Canisius High School  
Robert J. Stransky Memorial Athletic Complex  
Phase Three Development Project  
TA Project 20020

Town of West Seneca  
Town Hall  
1250 Union Road  
West Seneca, New York 14224

The following is an update on the progress since our last Planning Board meeting on June 10, 2021:

Canisius High School  
LRB 2021-01394  
Sheet 3 of 4

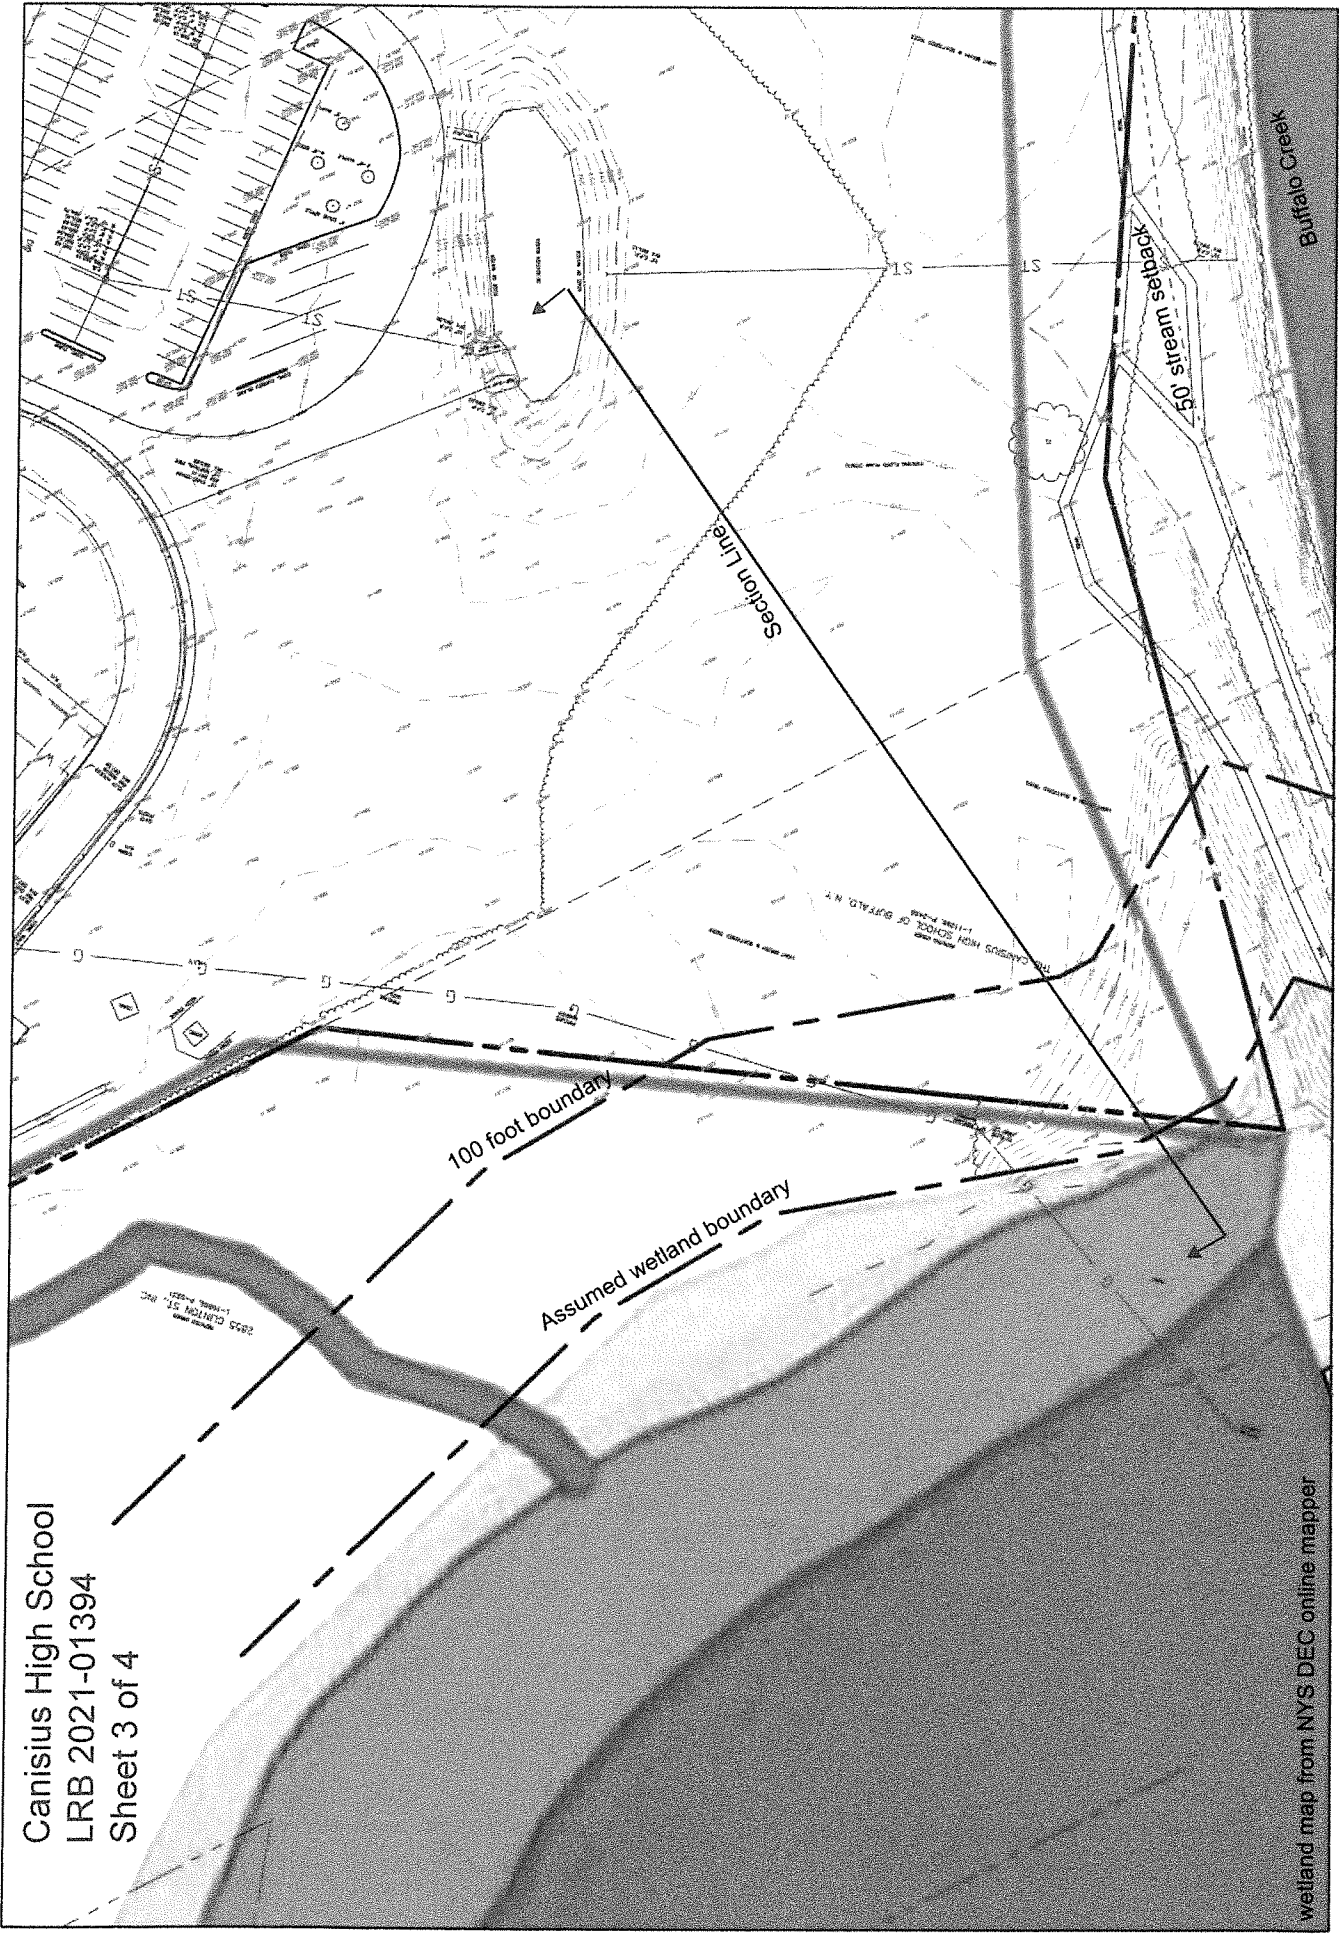
I have determined that the review area as depicted on Figure 3 of 4 is comprised entirely of dry land and contains no potential aquatic resources regulated under Section 404 of the Clean Water Act or Section 10 of the Rivers and Harbors Act of 1899. Therefore, a Department of the Army permit is not required for any activities occurring within the review area.
